**CITY OF EDGERTON
EDGERTON CITY HALL
12 ALBION STREET
EDGERTON, WI**

PLANNING COMMISSION
Wednesday, June 30, 2021 at 6:00 P.M.

TO: Edgerton Plan Commission

Description of Request: Approval of a Precise Implementation Plan for a Planned Development to allow the construction of nine duplexes

CITY OF EDGERTON
 WEST MEADOWS
 SUBDIVISION DEVELOPMENT
 FIRE TRUCK TURN DIAGRAM

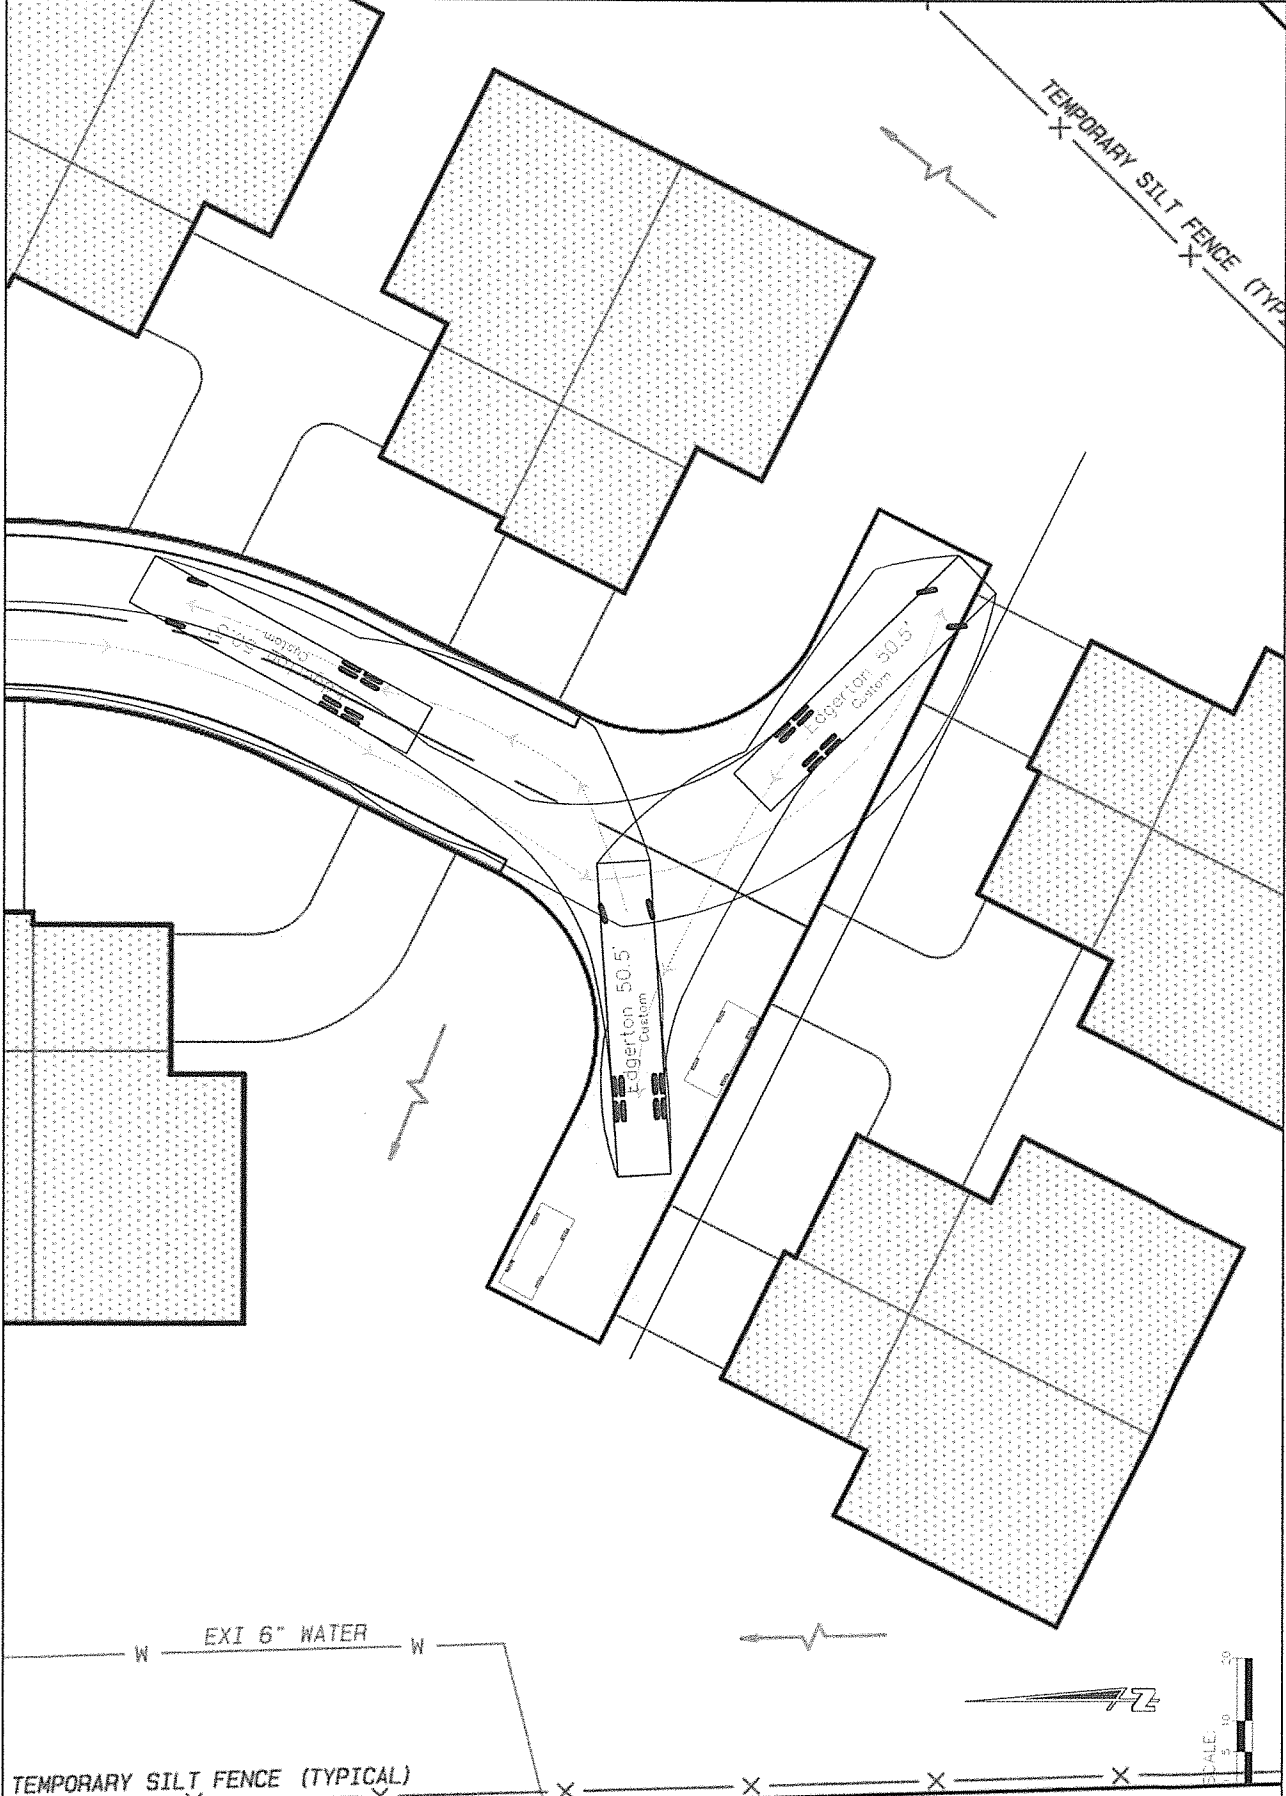
4. Each unit has a two-car garage. The garages are all in the front of the structures. The floor plan indicates one of the garages face the street while the other garage has a side access thus the garage door does not face the street. The front doors to the units face the street. Each unit has 2 parking spaces in front of the garage. The conventional standard for minimum permissible street width with one side parking is 29’ wide. Using this standard, one side on-street parking could be allowed by the condo association. There have been no other accommodations for parking as discussed during the GDP approval. 2-3 parking stalls could be provided in the hammer head as indicated in the attached sketch showing fire truck turning motions.

16. The condominium documents prohibit parking the hammerhead turn around except for the western end to ensure fire truck access. (see attached diagram)

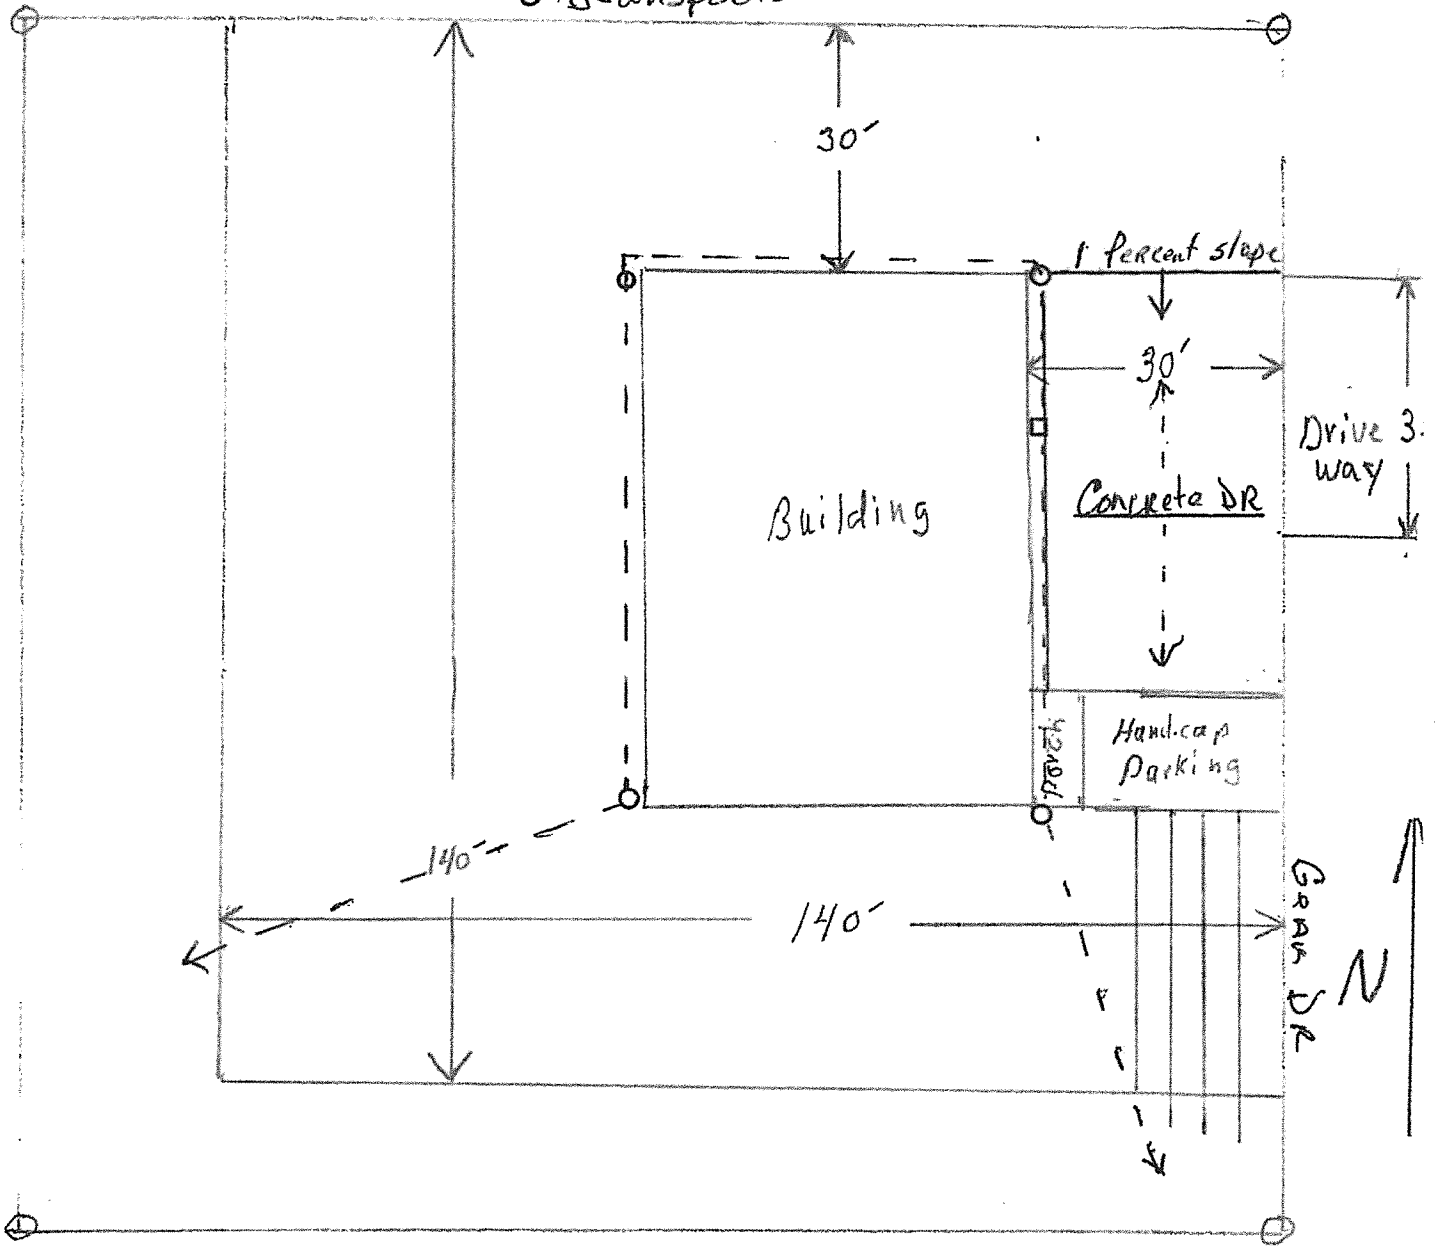
3. The site complies with the: landscape surface ratio; building setbacks; lot dimension, area, and height; parking standards of the zoning ordinance; and the restrictive covenants. The plan should be amended to show the required 10' setback for the pavement (other than the driveway) from the front property line.

6. Storm water drainage from the building and parking area will generally travel from the north to the south and southwest overland to the existing ditch on the south side and the regional pond on the west side of the site. Roof drainage will be collected in gutters that will drain to turf on the south end of the building. The building floor elevation will be slightly higher than the curb at its highest spot to ensure positive drainage.
7. The gas meter will be located on the south side of the building. These utilities should be screened as part of the landscape plan.
8. The petitioner does not plan to have a dumpster. If one is installed in the future it must comply with the location and screening requirements.
9. Wall pack lights will be located over the loading docks. The petitioner does not plan to provide parking lot lighting.

1. The petitioner obtains a sign permit if a sign is planned.
2. Outside utilities are screened.
3. The petitioner provides landscaping between the parking lot and the building and around the site utilities. The petitioner must provide a landscape plan having a total of 122 landscape points.
4. The Plan Commission determine if curbing will be required.
5. The optics of the building lighting are “cut-offs” that restrict light from spilling from the site.
6. The plan is amended to show the required 10’ setback for the pavement (other than the driveway) from the front property line.
